**PROPOSED TECHNICAL SPECIFICATION CHANGES ASSOCIATED WITH THE
INCREASE OF FUEL ENRICHMENT TO 5.0 WEIGHT PERCENT URANIUM-235**

NEW YORK POWER AUTHORITY
INDIAN POINT 3 NUCLEAR POWER PLANT
DOCKET NO. 50-286
DPR-64

**SAFETY EVALUATION OF THE
PROPOSED TECHNICAL SPECIFICATION CHANGES ASSOCIATED WITH THE
INCREASE OF FUEL ENRICHMENT TO 5.0 WEIGHT PERCENT URANIUM-235**

SAFETY EVALUATION RELATED TO
PROPOSED TECHNICAL SPECIFICATION CHANGES ASSOCIATED WITH THE
INCREASE OF FUEL ENRICHMENT TO 5.0 WEIGHT PERCENT URANIUM-235

Figure 3.8-1
Spent Fuel Pit Region 1 Type Definition

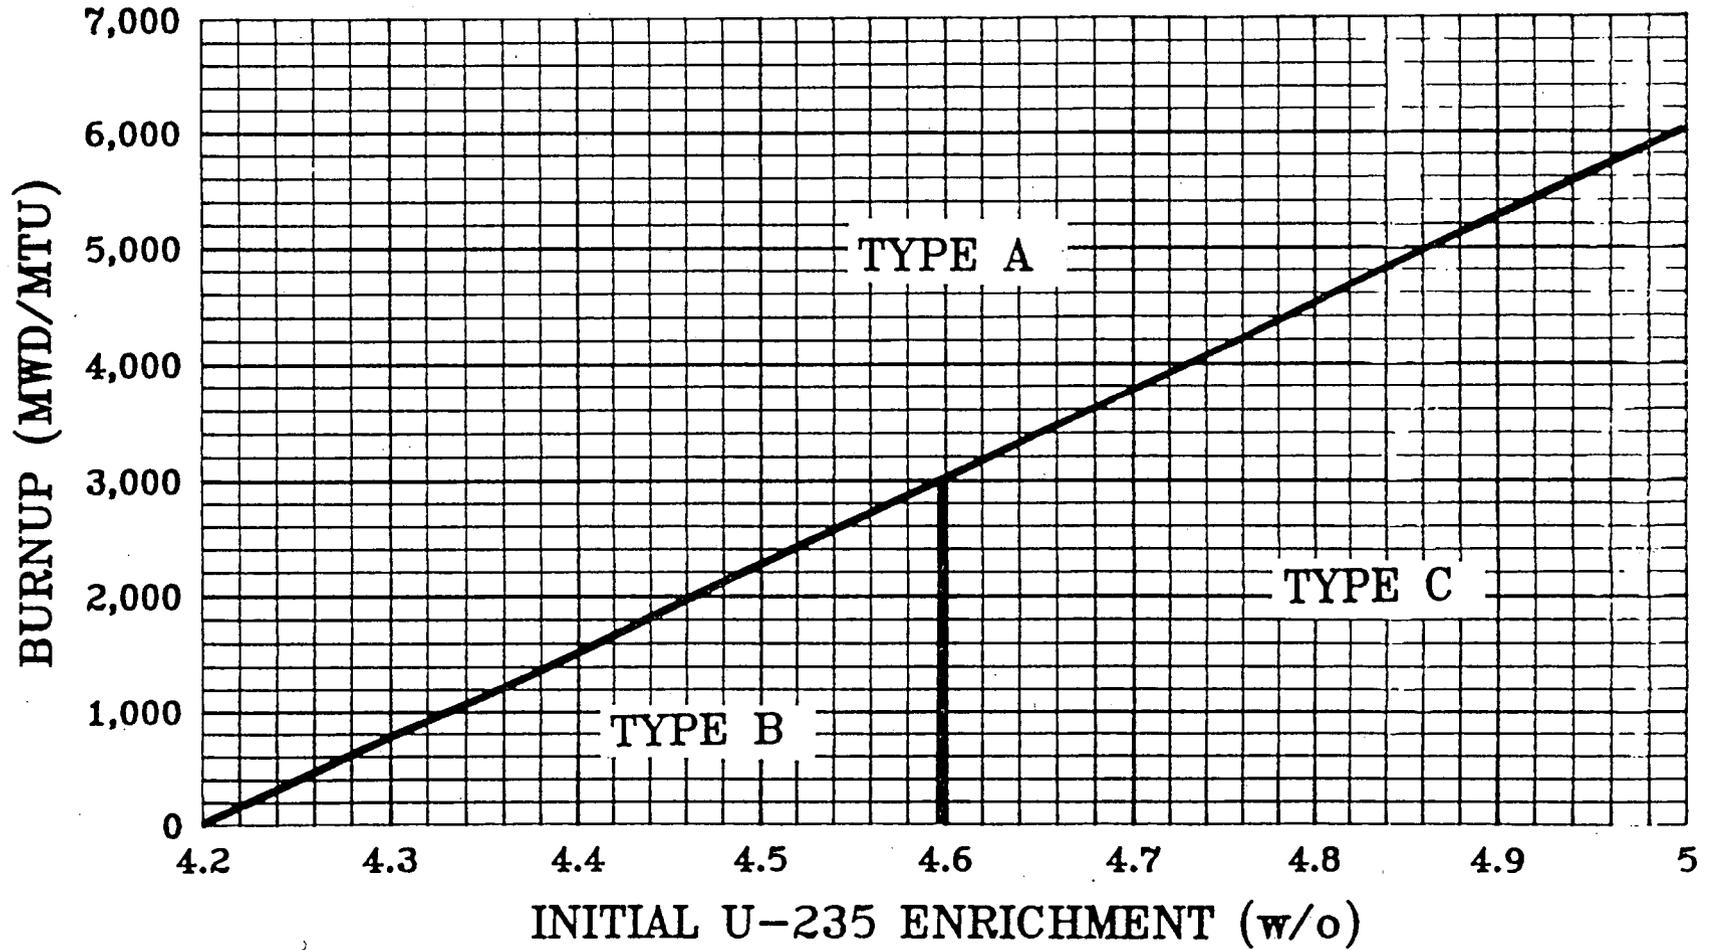
- a. As specified in Figure 3.8-2, fuel assemblies to be stored in Region 2 shall have a minimum burnup exposure as a function of initial enrichment.
 - b. As specified in Figure 3.8-1, fuel assemblies to be stored in Region 1 consist of 3 types (Type A, B, C), depending on their initial enrichment and current burnup. Restrictions on location of fuel in Region 1 are as follows:

The Region 1 area has also been analyzed for storage of high-enrichment and low-burnup fuel. Figure 3.8-1 categorizes Region 1 fuel assemblies as a function of their initial enrichment and current burnup into Types A, B, and C. Each type has different restrictions as to how it may be stored in Region 1. The least reactive assemblies, which are Type A assemblies, may be stored anywhere in Region 1. The most reactive assemblies, which are Type C assemblies, are stored only in Region 1 with the restrictions of Technical Specification 3.8.C.7.b.3, due to their high reactivity. Type C assemblies cannot be stored face-adjacent to anything more reactive than Type A fuel assemblies. There are no additional restrictions defining storage requirements for diagonally-adjacent fuel assemblies in Region 1. In addition, to prevent a criticality interaction with Region 2 fuel assemblies, Type C assemblies cannot be stored in Column ZZ or Row 64.

The following criteria should be used to categorize Region 1 fuel assemblies. Unburned fuel assemblies at or below 4.2 w/o enrichment are Type A. Unburned fuel assemblies at or below 4.6 w/o enrichment (but greater than 4.2 w/o enrichment) are Type B. Fuel assemblies whose burnup puts them on or above the diagonal line below the Type A zone are defined as Type A.

Figure 3.8-2
Region 2 Burnup Requirements for Fuel
Assembly Storage in Spent Fuel Pit

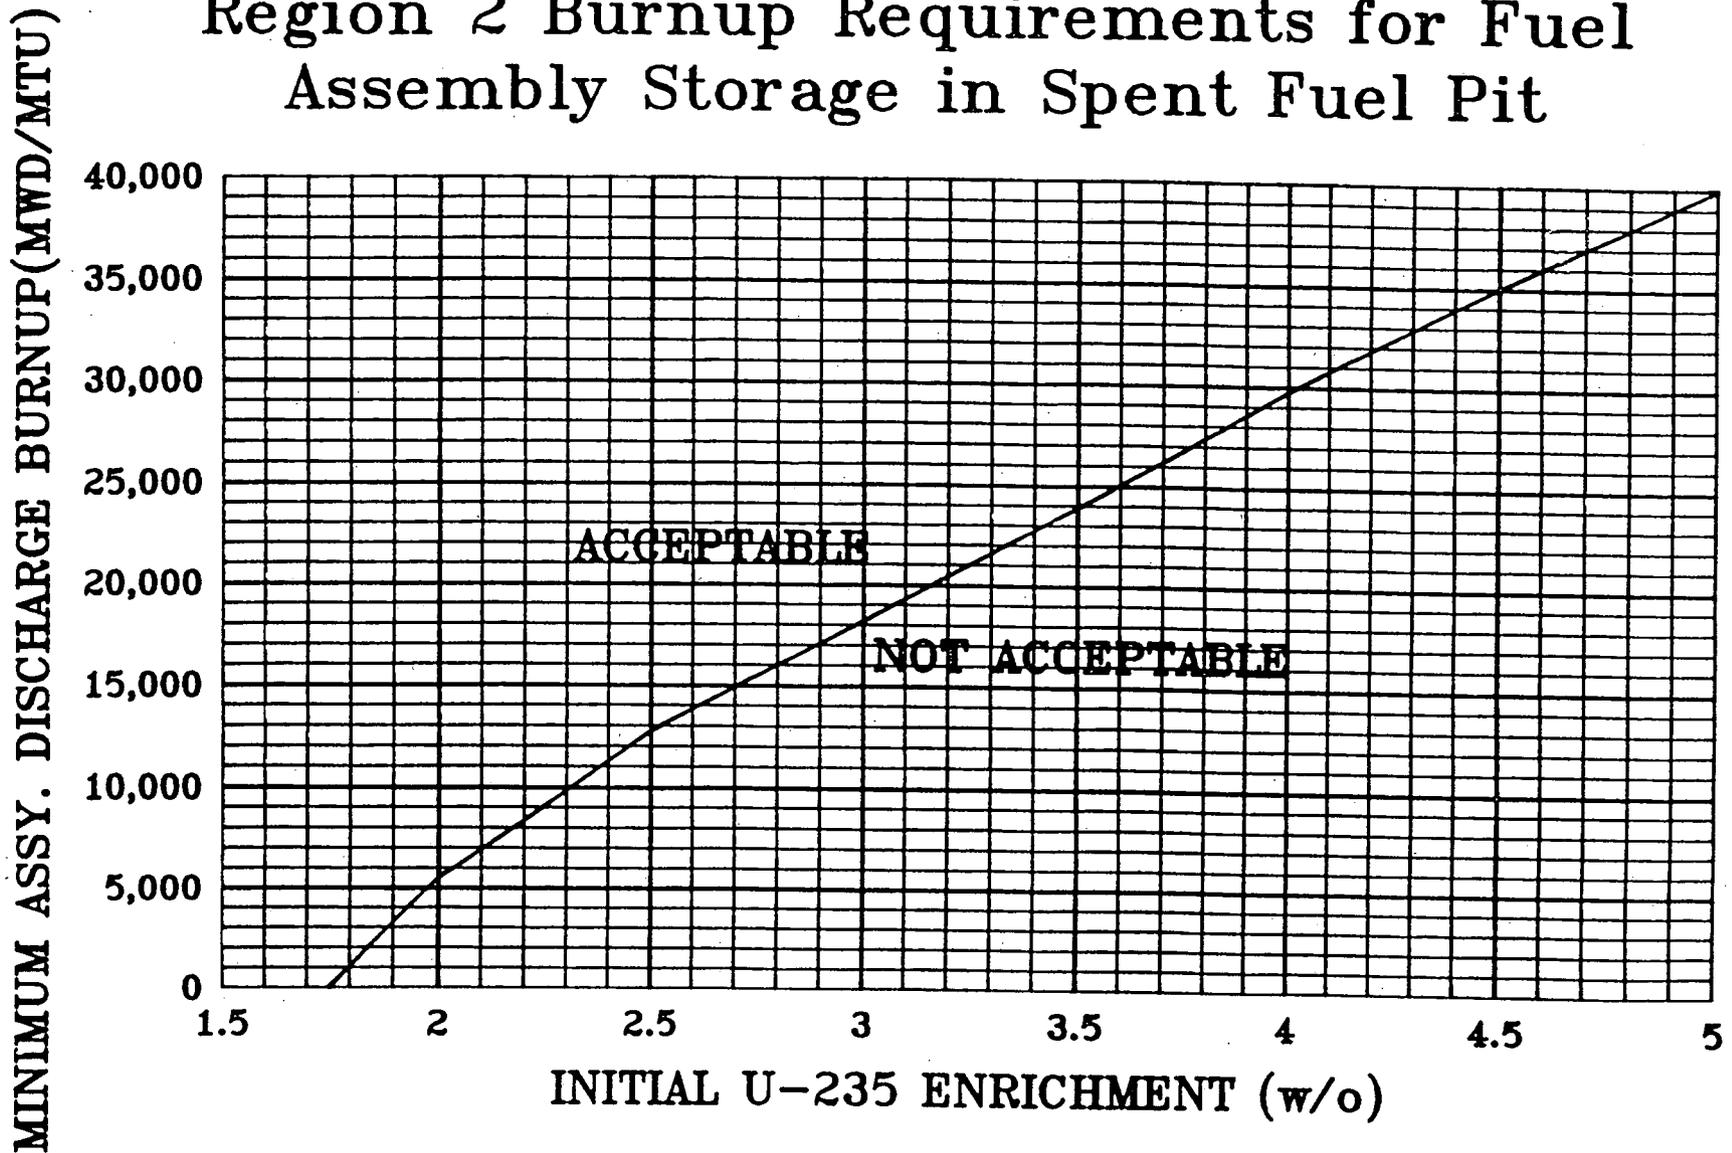
Fuel assemblies to be stored in Region 2 of the spent fuel racks must have a minimum burnup exposure as a function of initial enrichment as specified in Figure 3.8-2. Administrative controls will provide verification that each fuel assembly to be placed in Region 2 satisfies the burnup criterion.
